Amendment to the Drawings:

- - REMARKS - -

Fig. 3

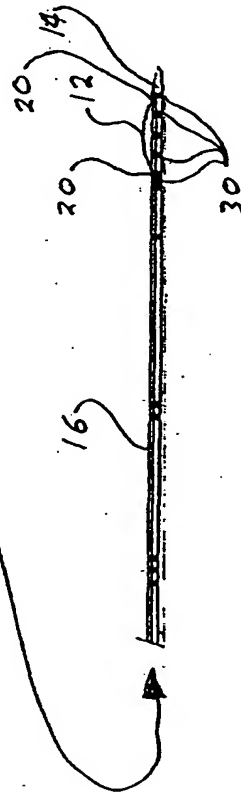
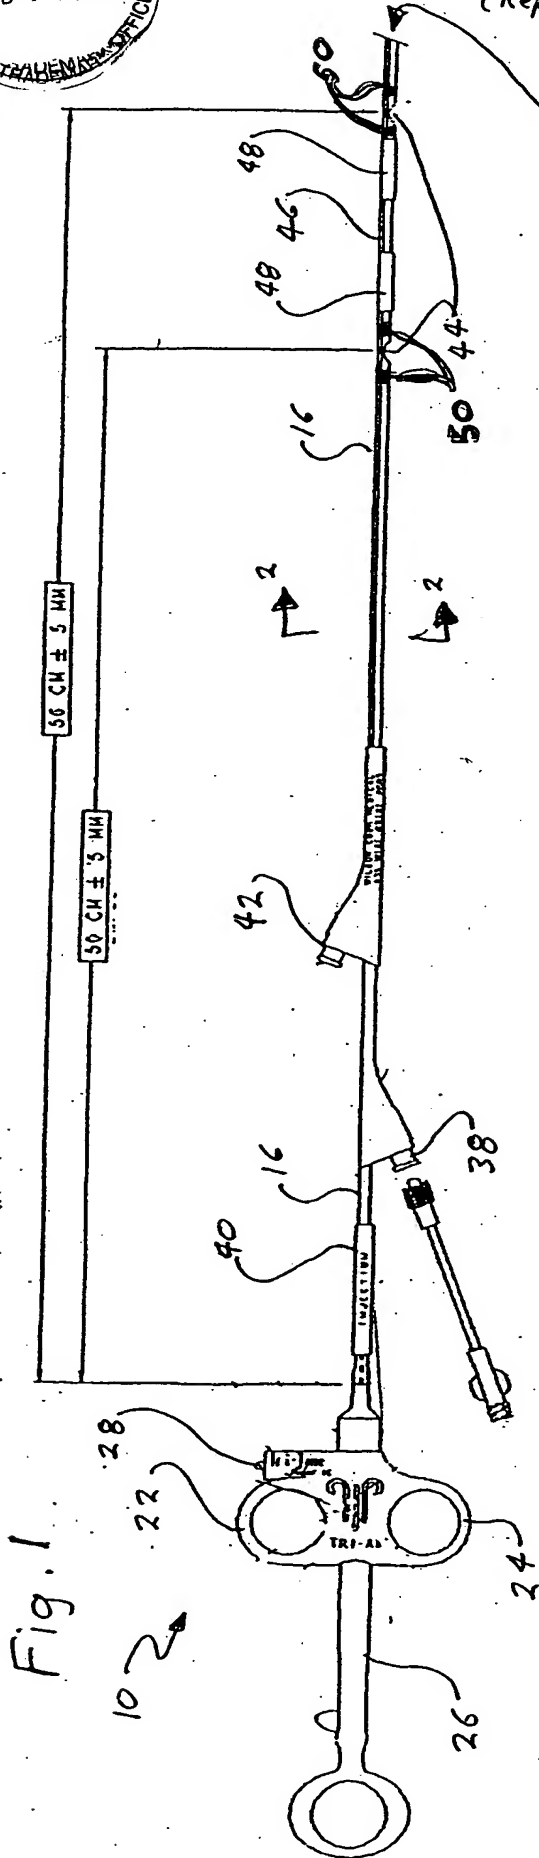
Please replace original drawing sheets 1/2 and 2/2 with the corrected Replacement Sheets 1/3 and 2/3 attached hereto. The corrected drawing sheets include the addition of element numbers to Figs 1 and 3. The changes to the drawings are shown in red on the Annotated Mark-up Drawings that are likewise attached hereto.

In the outstanding Office Action, the drawings have been objected to under 37 CFR 1.83(a) because the figures purportedly fail to show certain features or element numbers described in the specification. As a consequence, the drawings have been amended to include the missing element numbers and features. In particular, Figure 1 has been amended to include an element number (50) referencing the markers adjacent to the intermediate wire guide access ports, as those markers are described in paragraph [0026] of the specification. A corresponding amendment has been made to paragraph [0026]. In addition, Figure 3 has been amended to include element numbers (42, 44 and 48) that are shown in Figure 1 and described in, for example, paragraph [0024] of the specification. A Figure 3A has also been added to illustrate the arrangement described in the last two sentences of paragraph [0024] of the specification, i.e., wherein the more distal intermediate access port (44) may end up inside the handle (64) of the endoscope (60). A reference to Figure 3A has been added to paragraphs [0017] and [0024]. Applicants believe that the Examiner's objections to the drawings under 37 CFR 1.83(a), particularly with respect to the non-cancelled claims, have been overcome by the corrections to Figures 1 and 3, and the addition of new drawing Figure 3A.
